Jackson County Board of Commissioners

RE: Addendum 1 to Jackson County ITB 240003, Jackson County Government Complex Entrances Landscaping, Jackson County Government

**JACKSON
PARKWAY
LANDSCAPE
IMPROVEMENTS**

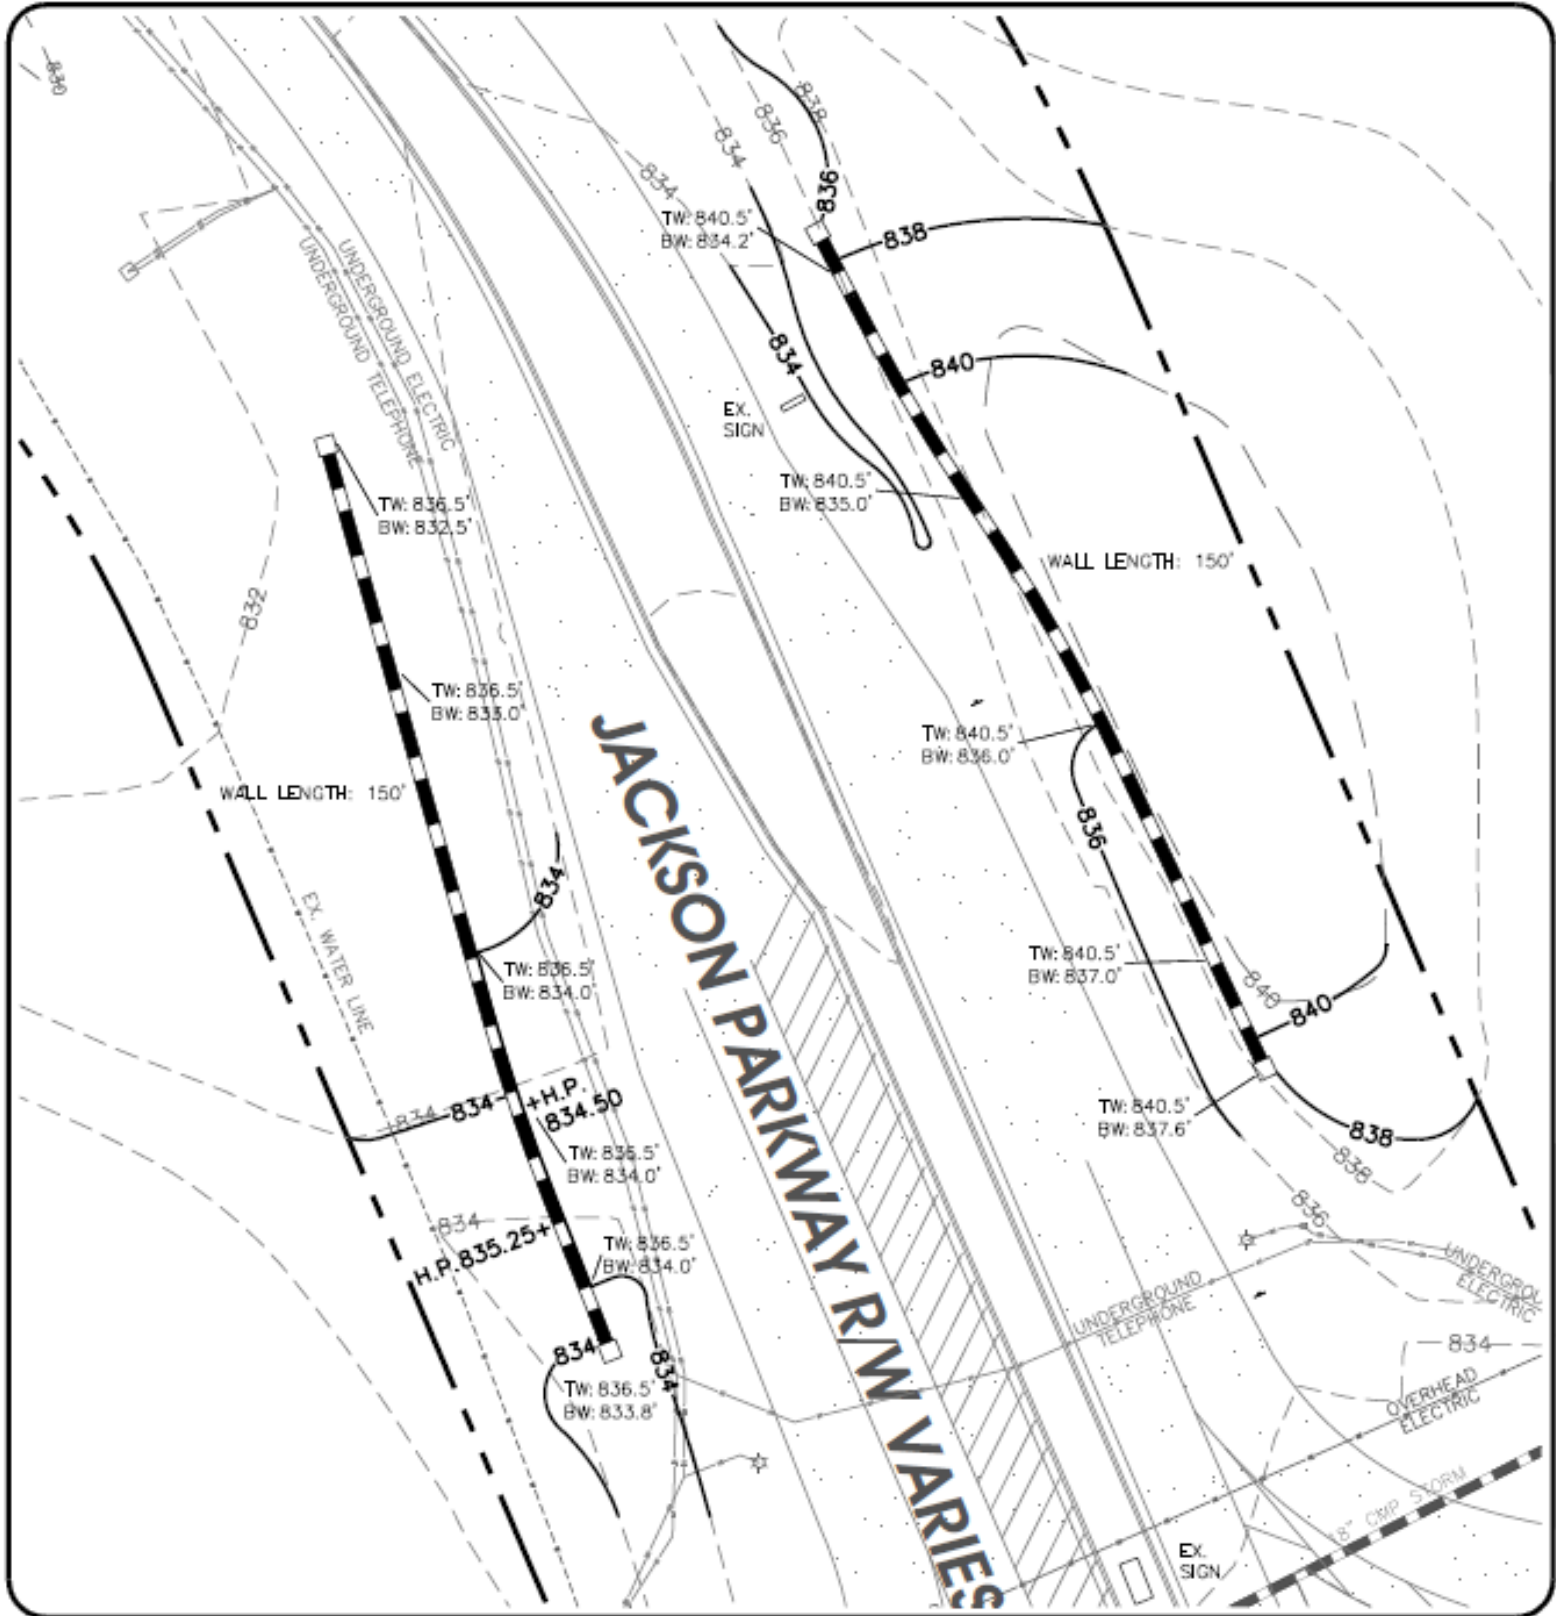
4. Is there an average height for the retaining walls since the plans do not show any elevations?
 - A. **Appendices A & B for Wall Addendums East & West** attached.
